Access Compliance Report Public Rights-of-Way (Curb Ramps)

Main Street: ETON_PL Cross Street: ETON_PL Location: NE

ADA ID: RPRK211026143800 Ramp Type: Type 4 - Parallel Initial Pass/Fail: Fail Overall Compliance: No Severity Score: 2

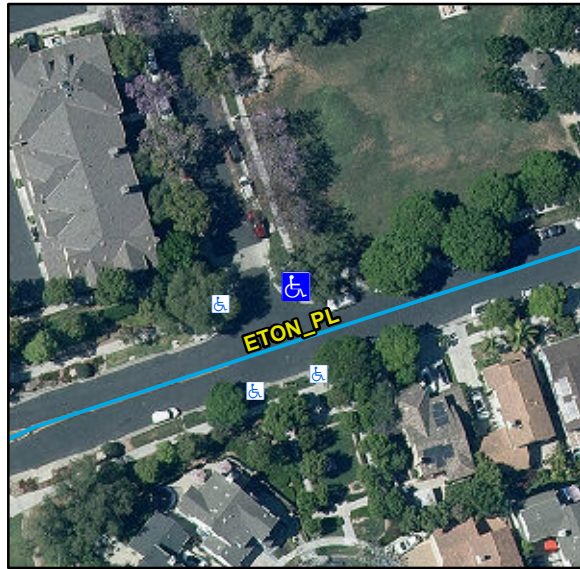
Compliance	Description	Data	Compliance	Description	Data
N/A	Ramp Length LT (in)	108	N/A	Ramp Length RT (in)	125
Yes	Ramp Width LT (in)	92	Yes	Ramp Width RT (in)	94
Yes	Ramp Run Slope LT (%)	4	Yes	Ramp Run Slope RT (%)	6.2
No	Ramp Cross Slope LT (%)	2.9	No	Ramp Cross Slope RT (%)	2.4
N/A	Landing Present	N/A	N/A	DWS Provided	N/A
N/A	Landing Length (in)	N/A	N/A	DWS Contrast	N/A
N/A	Landing Width (in)	N/A	N/A	DWS Length (in)	N/A
N/A	Landing Run Slope (%)	N/A	N/A	DWS Full Width	N/A
N/A	Landing Cross Slope (%)	N/A		DWS Offset Type	N/A
N/A	Landing Movement Obstructed?	N/A	N/A	DWS Offset Left (in)	N/A
	Landing Movement Type	N/A	N/A	DWS Offset Right (in)	N/A
N/A	Landing Shared	N/A			
N/A	Clear Space	Yes			
N/A	Clear Space To Crosswalk (in)	N/A			
N/A	Marked Crosswalk 1	No	N/A	Marked Crosswalk 2	No
	Crossing 1 Direction	W		Crossing 2 Direction	S
	Marked Crosswalk 1 Width (in)	N/A		Marked Crosswalk 2 Width (in)	N/A
N/A	Ramp Inside Crosswalk 1	N/A	N/A	Ramp Inside Crosswalk 2	N/A

Remove & Replace Curb Ramp With Two New Directional Ramps or Equivalent.
